**CITY OF MENASHA  
PLAN COMMISSION  
Council Chambers  
140 Main Street, Menasha**

**February 21, 2012  
3:30 PM**

**Community Development Department  
Plan Commission Staff Report  
February 16, 2012**

**Agenda Item F.2. Appanasha Pet Clinic, 1205 Wittmann Drive, Parcel 6-01647-00**

# LANDSCAPE PLAN

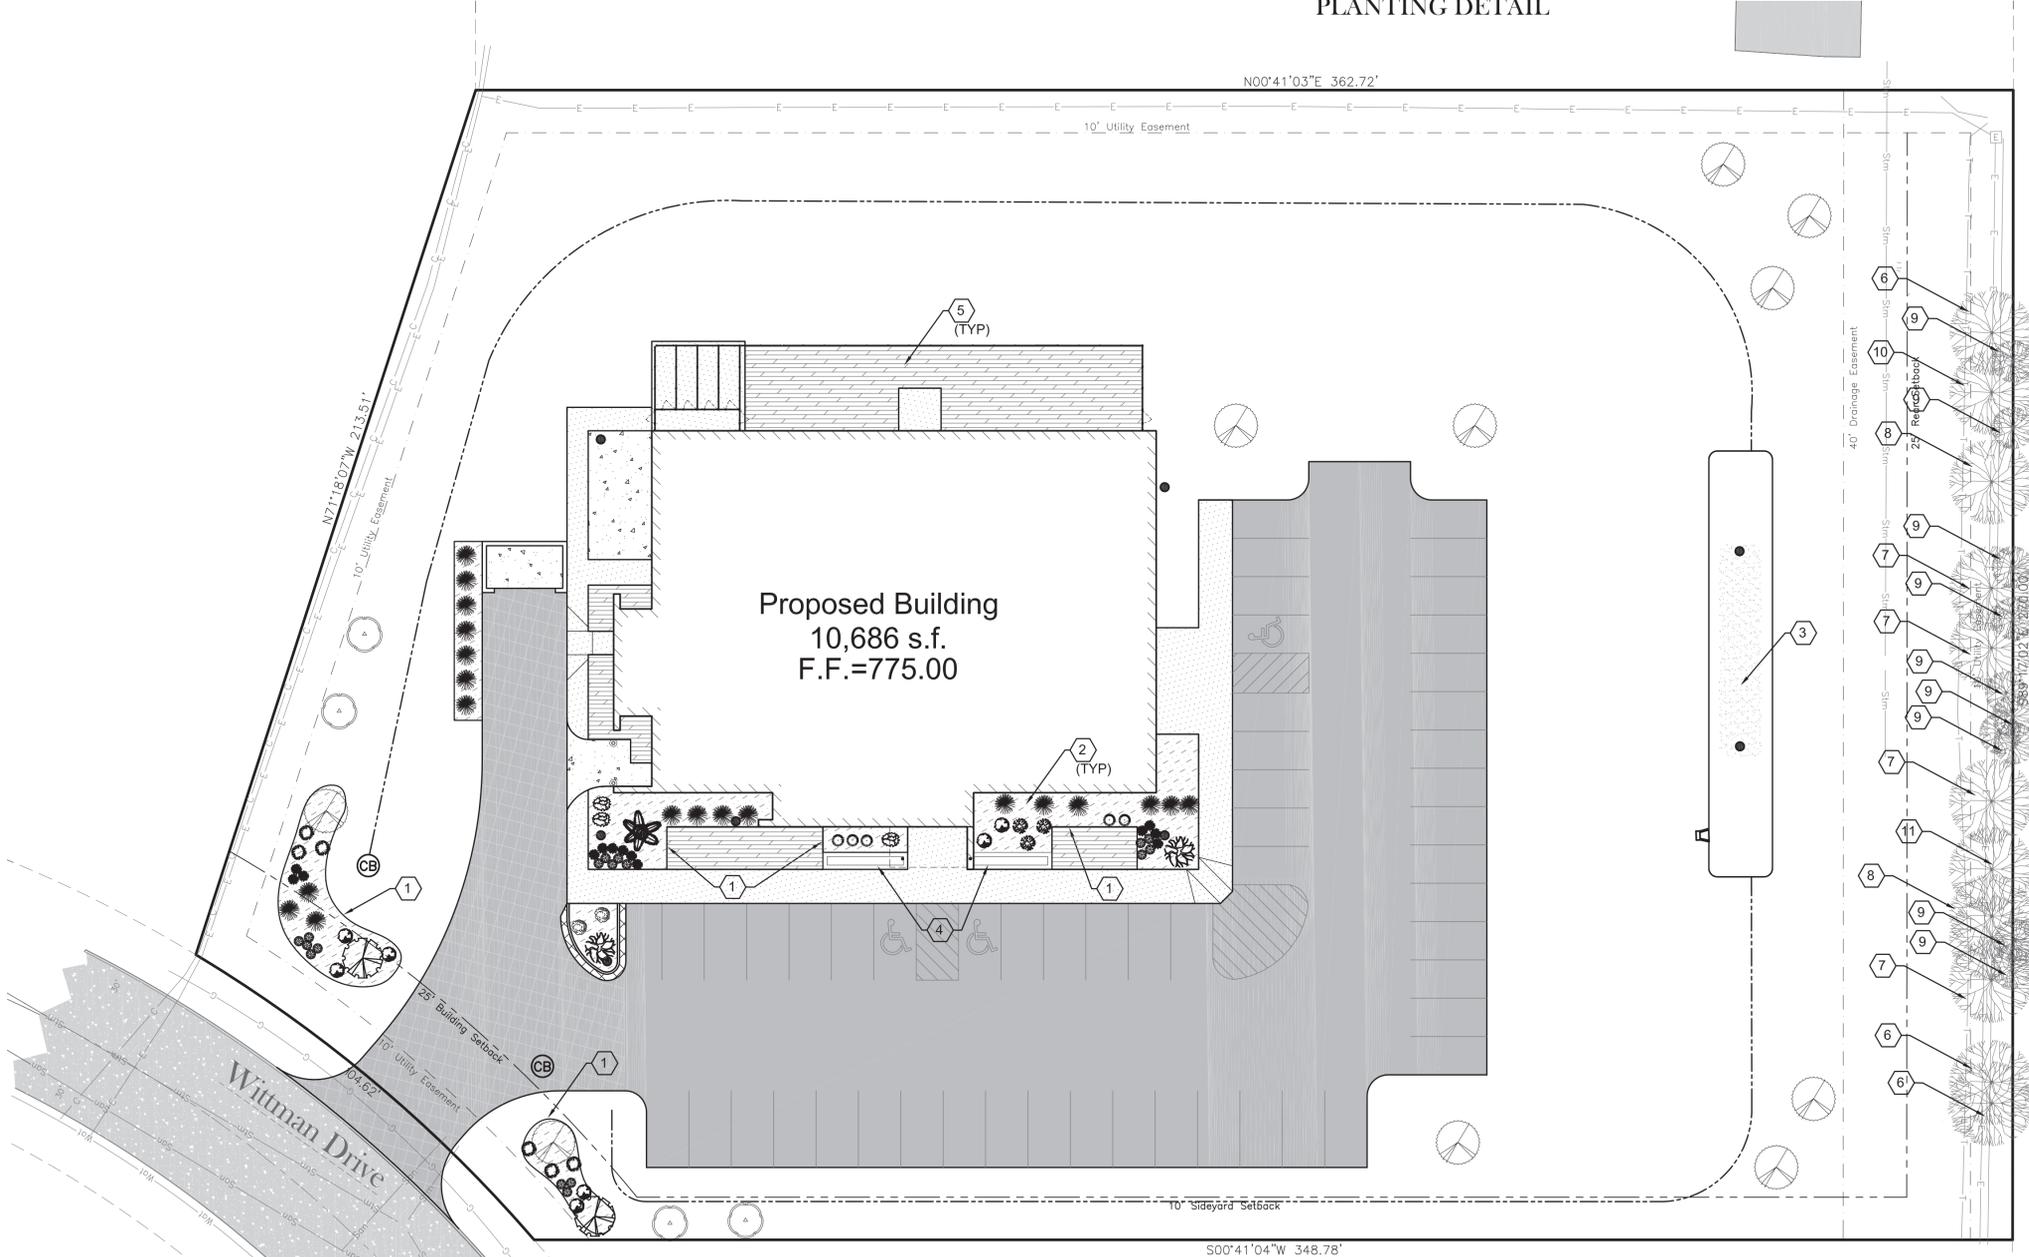
The minimum landscaping requirement for the C-4 District is 20 percent of the site area. Approximately one-third of the site is comprised of building and parking. Additional landscaping is needed in the parking lot interior and along the building perimeter on the north side of the building. There is no specification given for the vegetative cover of portions of the site that are not part of the building footprint, parking lot or landscape beds. The existing vegetation should remain as-is within the drainage easement unless advised otherwise by the Public Works Department (portions of the transitional area planting may extend into the drainage easement, but should not encroach upon the ditch profile).

Transitional landscaping is required, as the proposed commercial use abuts a R-4 multifamily use to the south. Use of existing vegetation is proposed to meet part of the transitional area requirements. The existing vegetation was reviewed by Community Development staff and the City Forester. Much of what is present is comprised of invasive species or otherwise unsuitable plant materials. The specific findings have been forwarded to the site designer and a revised transitional area plan is being prepared.

- The transitional area be revised to comply with ordinance requirements
- The parking lot interior landscaping be revised to meet ordinance requirements and to be submitted to the Community Development Department for review and approval.
- The landscaping plan be revised to include additional building perimeter plantings on the north elevations, and specifications be given for undesignated portions of the site.
- Approval of Stormwater and Erosion Control Plans by Public Works/Engineering staff.

**1** ELECTRICAL  
SITE PLAN  
1" = 30'-0"

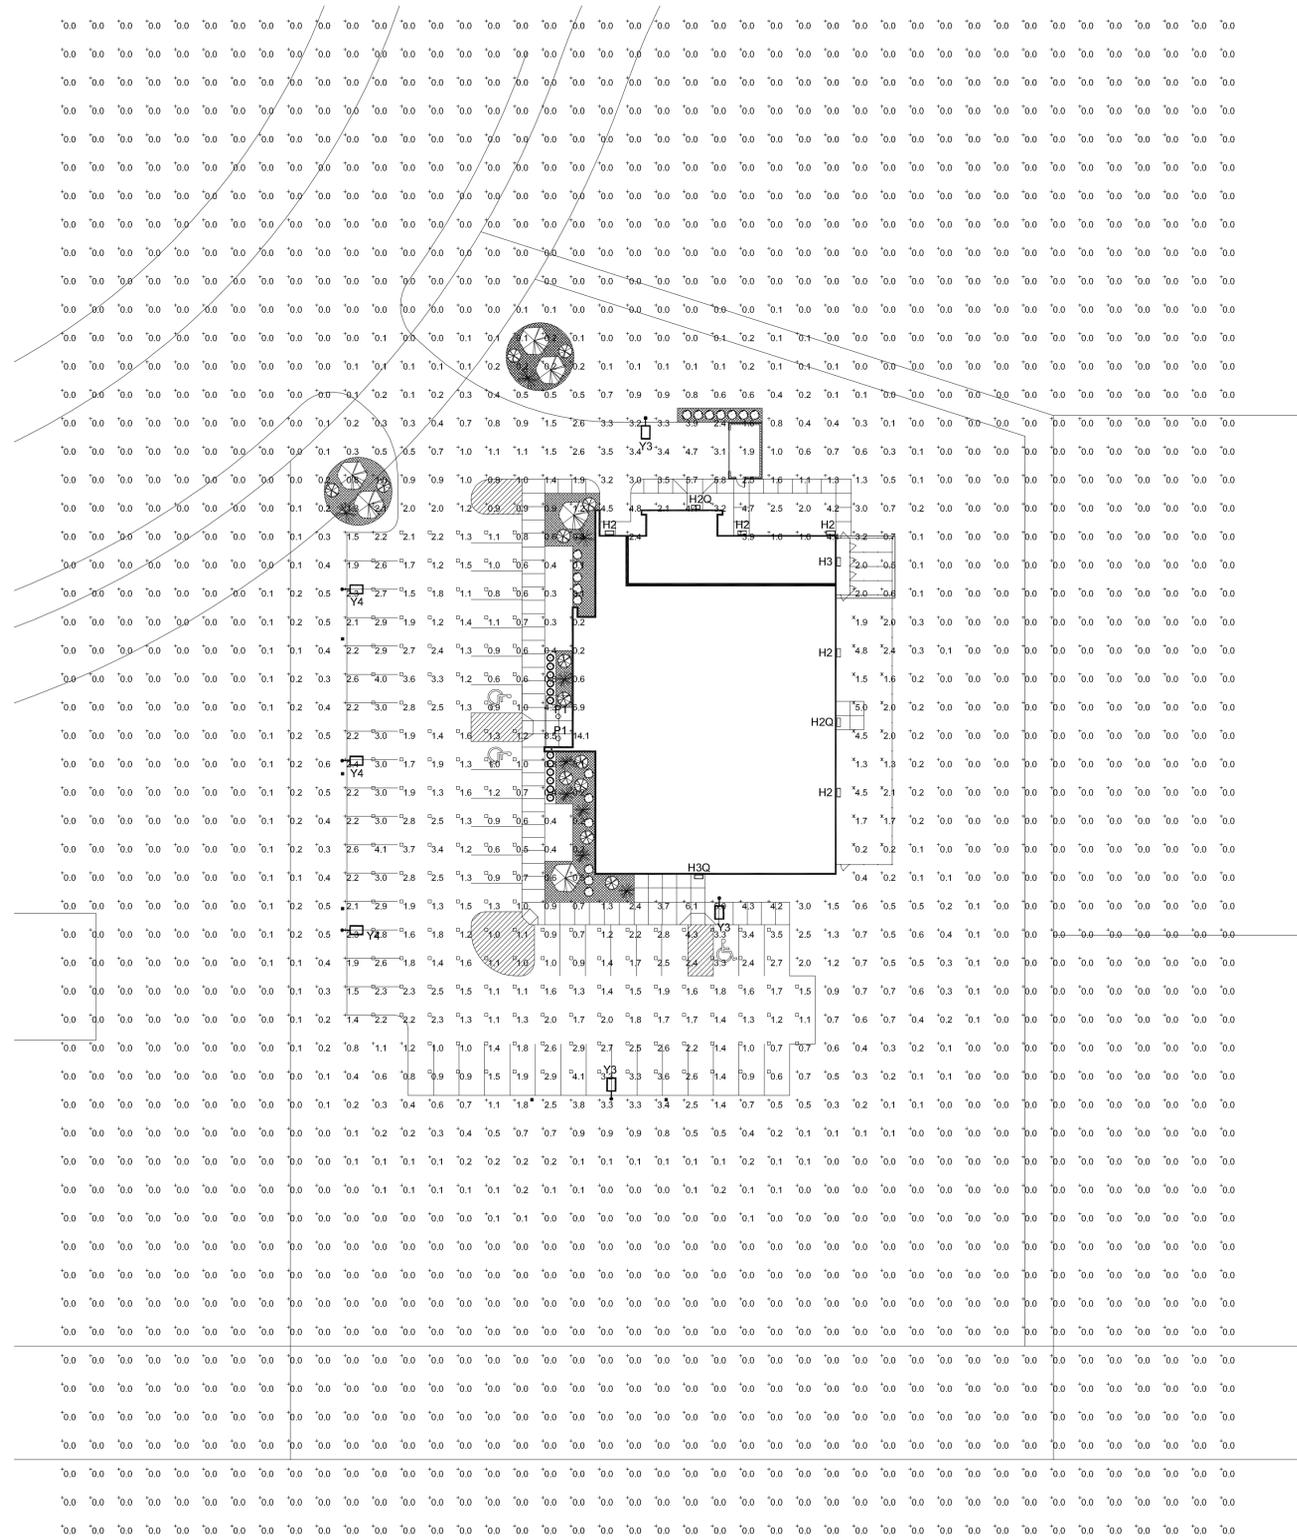
The photometric plan appears to comply with illumination standards.

# PROPOSED LANDSCAPE PLAN

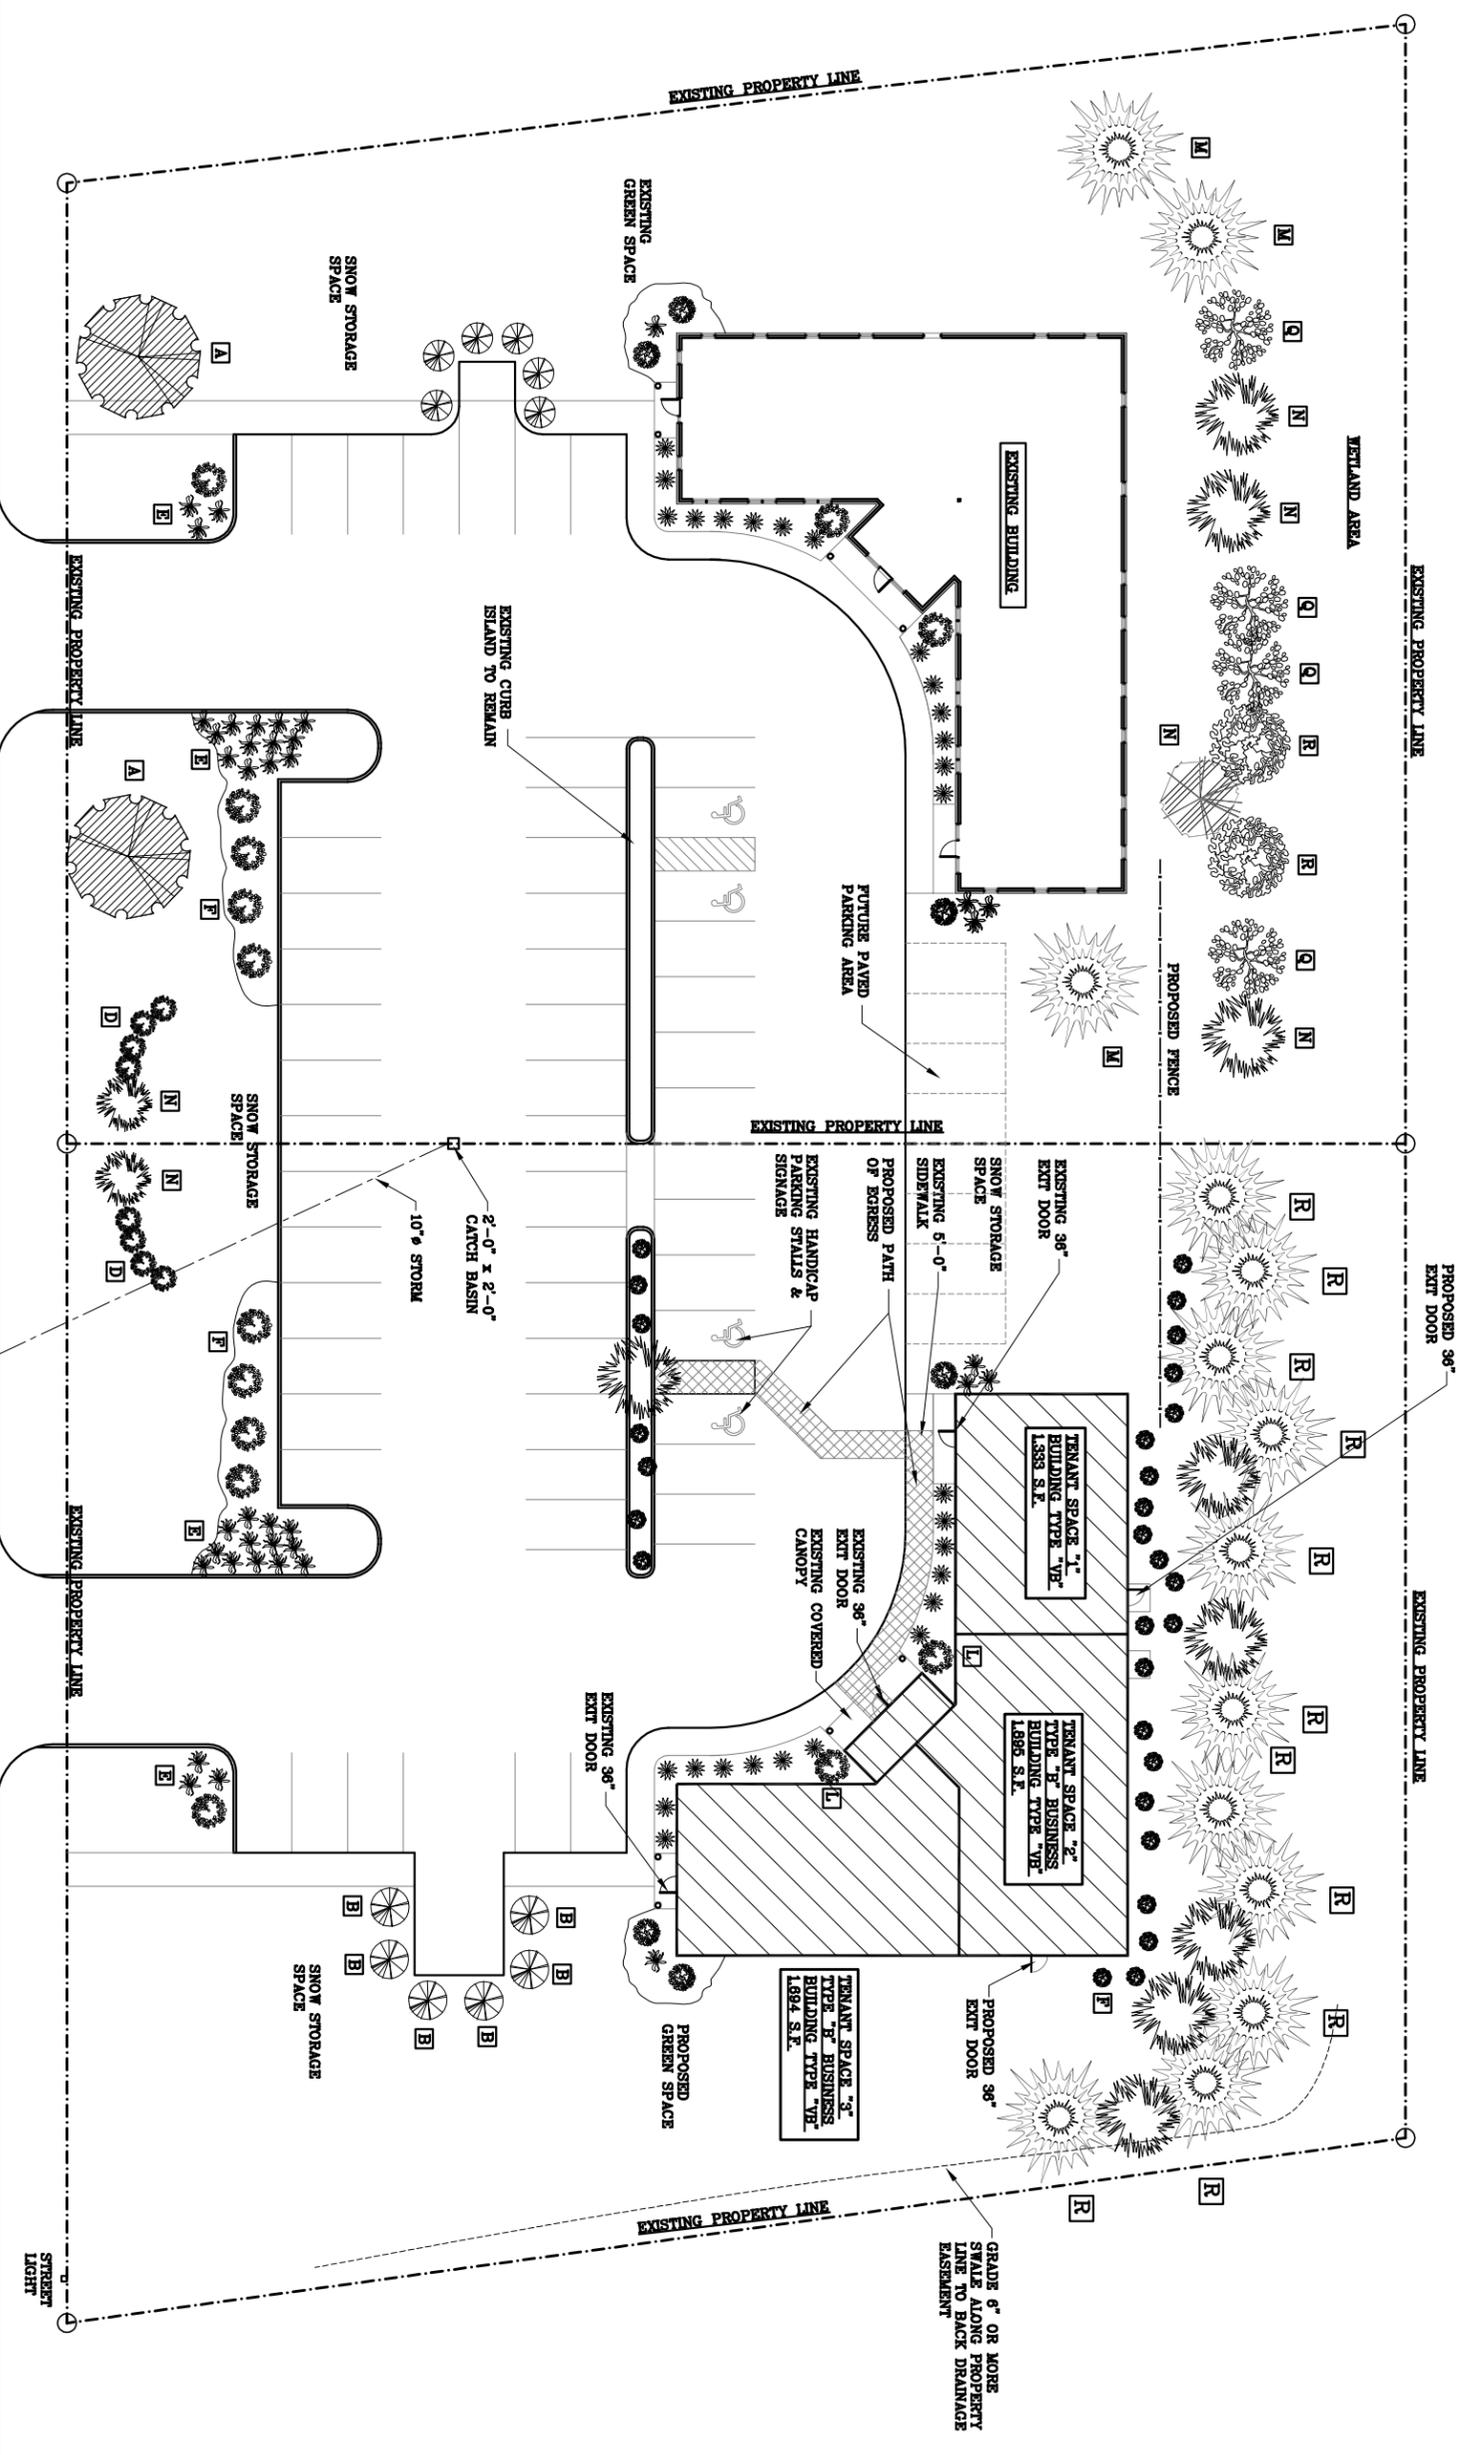
The C-3 District calls for the installation of 20% landscaping; the proposed plan appears to meet this requirement. Additional detail regarding specimen types and size is needed, especially for the transitional area and the parking lot landscaping.

As the property abuts R-1A to the East, a transitional landscaping buffer is required. The proposed landscape plan provides evergreen trees along with small shrubs along the foundation of the rear building façade, and a fence (to be constructed jointly with Salon Eternity) to screen the parking lot area and mitigate any light intrusion from parking lot traffic. A better mixture of

deciduous and evergreen, along with plant variety is needed to comply with the transitional area requirements. In addition, as the proposed transitional area utilizes fencing as part of the screening, Plan Commission must approve this as a suitable alternative for the site.

Staff's review of the parking lot landscaping (islands and perimeter), indicate that the proposed site plan is very close to complying with parking lot landscaping requirements. Two additional canopy trees are required between the parking Lot and Province terrace, along with more information on plant selection is required. In particular, shrubs for the parking lot perimeter screening must be at least 50% deciduous.

- Developer submits a lighting plan that is found acceptable by and approved by Community Development Staff, if not yet received and/or reviewed.
- Developer submits final design and materials for dumpster enclosure, which 75% opacity and be at least 6 feet in height.
- Developer submits a final landscaping plan to include the following:
  - Two additional deciduous canopy trees between the parking lot and Province Terrace
  - Revised planting scheme for the transitional area, to include a mix of deciduous and evergreen trees, and a greater variety of planting materials.
  - Parking Lot perimeter landscaping shrubs contain at least 50% evergreen.
  - Labeling of all planting materials, including proposed size and type.
